UNITED STATES PATENT AND TRADEMARK OFFICE

APPLICATION NO.	FILING DATE	FIRST NAMED INVENTOR	ATTORNEY DOCKET NO.	CONFIRMATION NO.
10/622,436	07/18/2003	Josef Ruppert	8178	4973

Office Action Summary

DETAILED ACTION

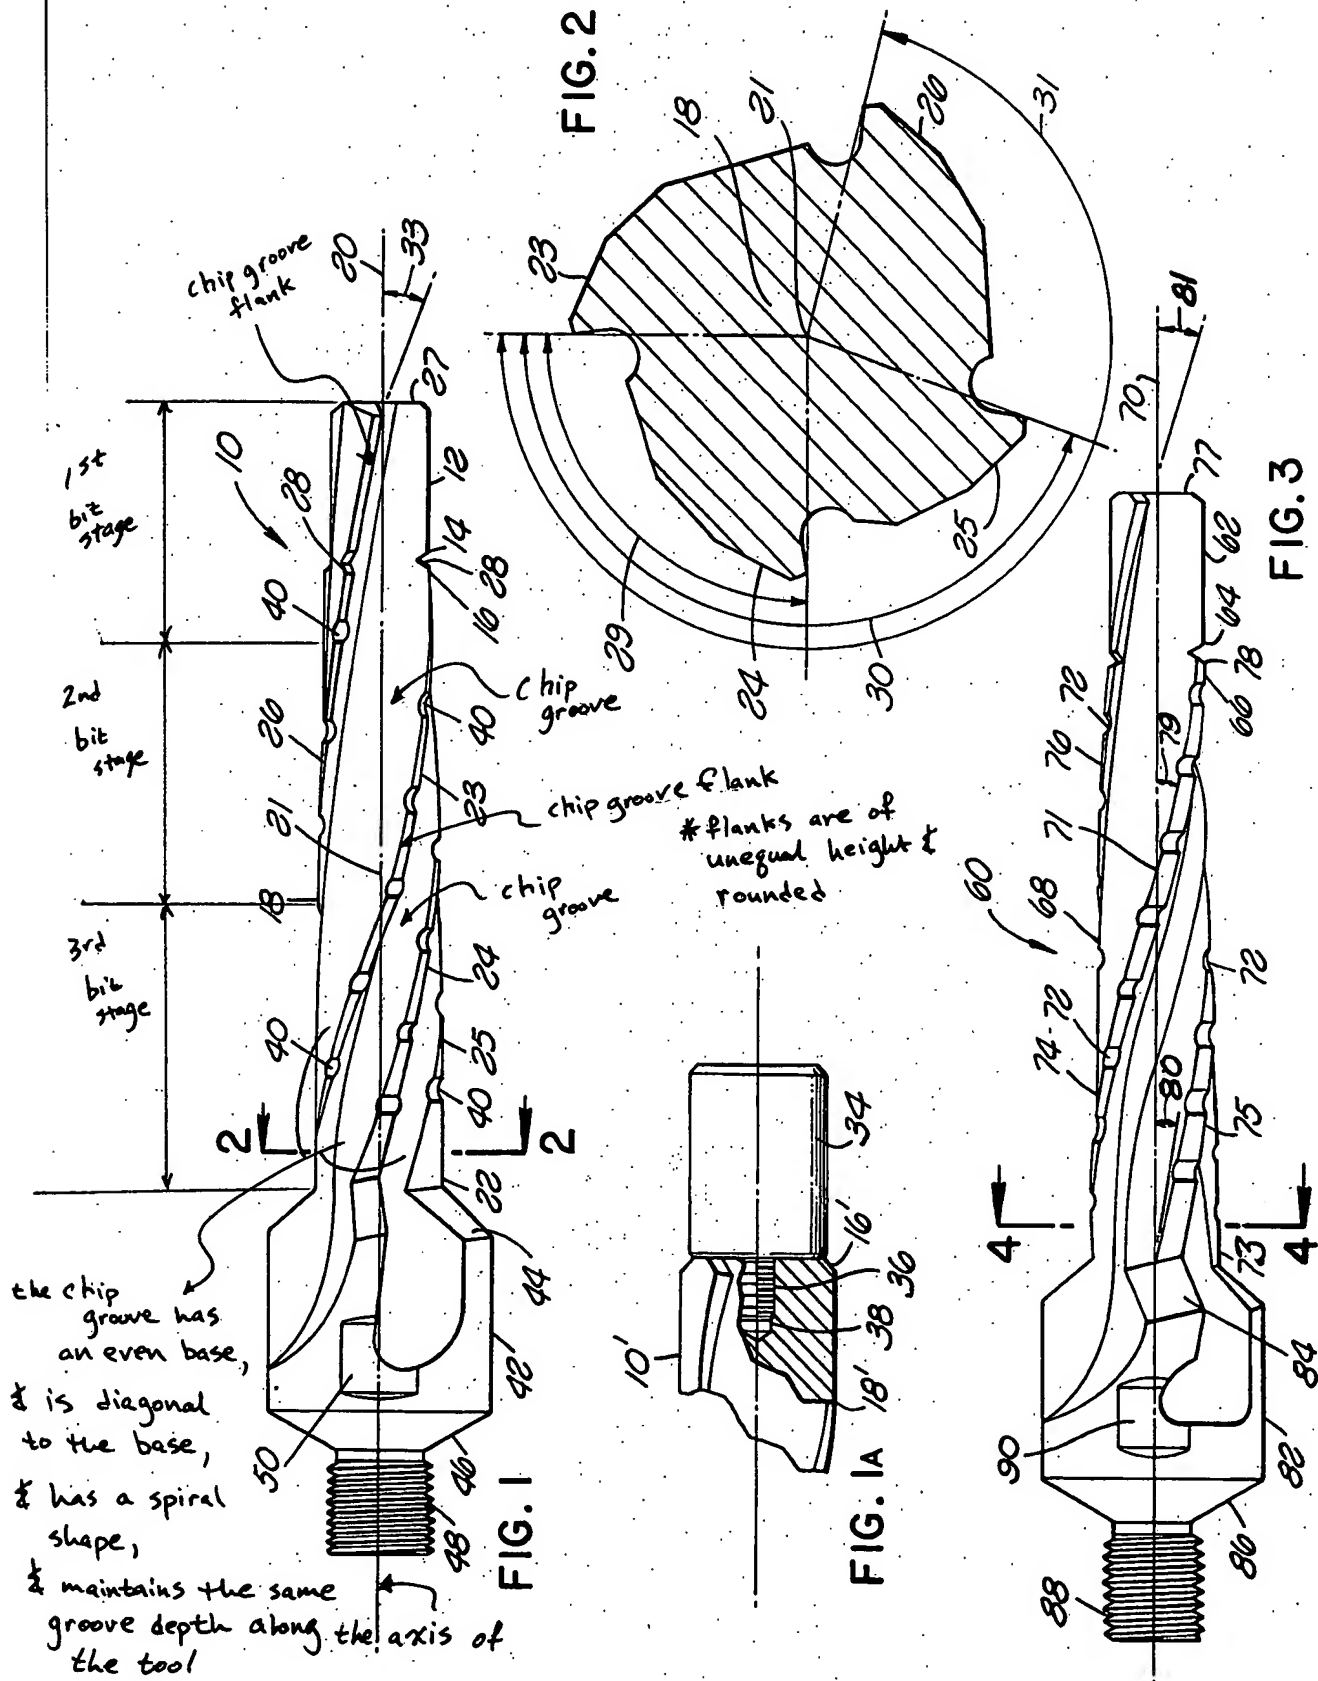
Arnold discloses a drilling tool (10) with a chip groove (see drawing attachment, fig.1), a first bit stage designed as a core bit (defined by reference numeral 27), and at least one second bit stage (see drawing attachment, fig.1) arranged in the form of a step (the step form is defined by the varying diameters of the different bit stages, which is more clearly seen in fig. 5). All of the bit stages have at least one common chip groove as seen in the drawing attachment, fig.1. The chip groove is also defined by the chip flutes 23, 26 and has an even base with the course of the chip groove having a spiral shape (see drawing attachment, fig.1). The chip groove also has flanks (defined by the right and left edges of the groove, which is also defined by the chip flutes 23, 26). The flanks are of unequal height (see drawing attachment, fig.1); the left edge of the chip groove is higher than the right edge of the chip groove). The flanks of the chip groove are in a diagonal orientation with respect to the groove base (see drawing attachment, fig.1), and the flanks have a rounded shape about the central axis 20 (see drawing attachment, fig.1). The path of the chip groove increases in diameter through the successive bit stages as can be seen in the drawing attachment, fig.1 (the increase in diameter can be more clearly seen in fig. 5), which forms an imaginary cone (the imaginary cone is defined by the tool having a cone shape as seen in figs.1, 5 of the drawing attachment). The depth of the chip groove has virtually the same depth throughout the bit stages as can be seen in fig.1 of the drawing attachment; the chip groove having the same depth throughout the tool can also be seen in fig. 2 of the drawing attachment.

FIG. 4

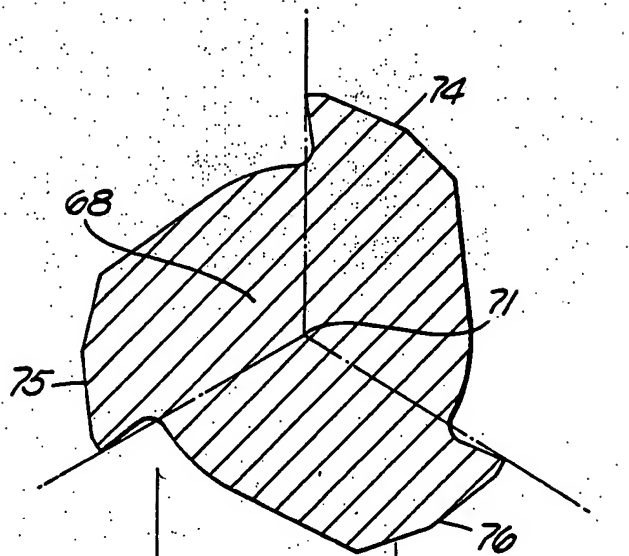
* the successive bit stages are increasing in diameter
